Item Name: Crosstube Turning Detail

DART AEROSPACE LTD	Work Order:	99886
Description: Crosstube Assembly (205/212/412 High Fwd)	Part Number:	D212-664-141
Inspection Dwg: D212-664-141 Rev: D		Page 1 of 2

DRAWING NO. D212-664-141	TITLE XTUBE ASSY (205/212/412 HI FWD)	REV. D	DART AEROSPACE LTD ENGINEERING ORDER		D.E.O. NO. D212-664-141-D-1	SHEET NO. SHEET 1 OF 2	SCALE NTS
DRAWN	CHECKED	OP	MFG. APPR.	APPROVED	DE APPR.		
DATE 11.04.07	DATE 11.07.11		DATE 11.04.12	DATE 11/04/12	DATE 11.04.12

ADD AN INSPECTION WINDOW TO UNDERSIDE OF CROSSTUBE.

**D212-664-141/-141B
ASSEMBLY DETAIL**

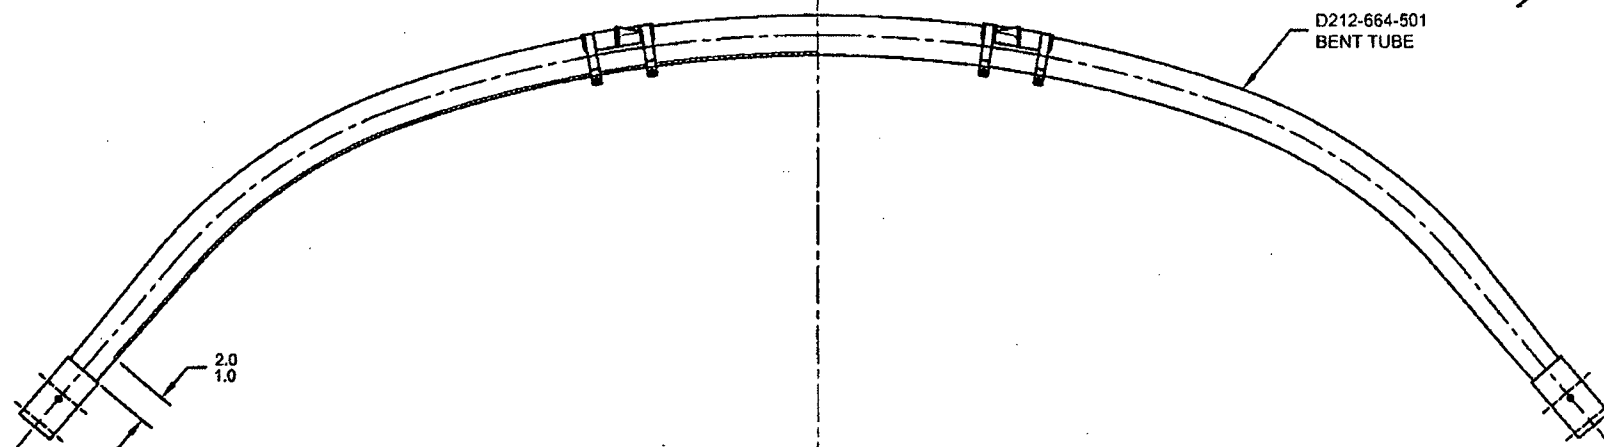
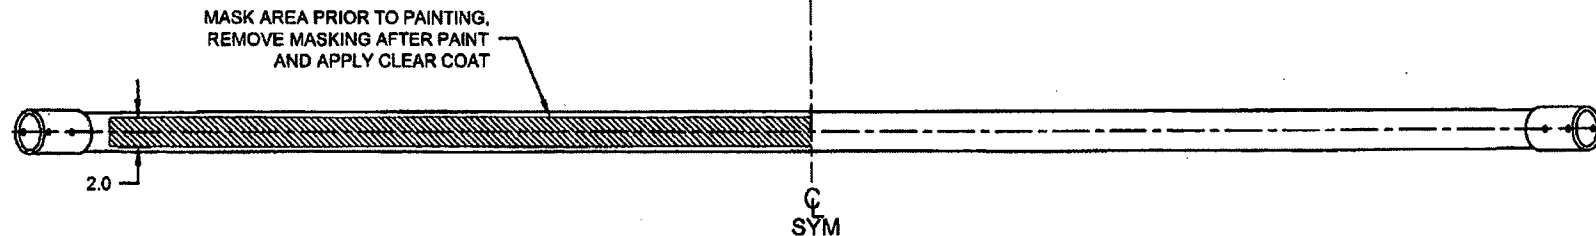
NOTES 2 OF SHEET 1 IS AMENDED AS FOLLOWS:

- 2) FINISH: CHEMICAL CONVERSION COAT PER DART QSI 005 4.1
PRIME INSIDE AND OUTSIDE PER DART QSI 005 4.2
MASK UNDERSIDE OF CROSSTUBE AS SHOWN (HATCHED AREA) AND
PAINT OUTSIDE PER DART QSI 005 4.2
REMOVE MASKING AND APPLY CLEAR COAT

- 2) FINISH: CHEMICAL CONVERSION COAT PER DART QSI 005 4.1
PRIME INSIDE AND OUTSIDE PER DART QSI 005 4.2
PAINT OUTSIDE PER DART QSI 005 4.2
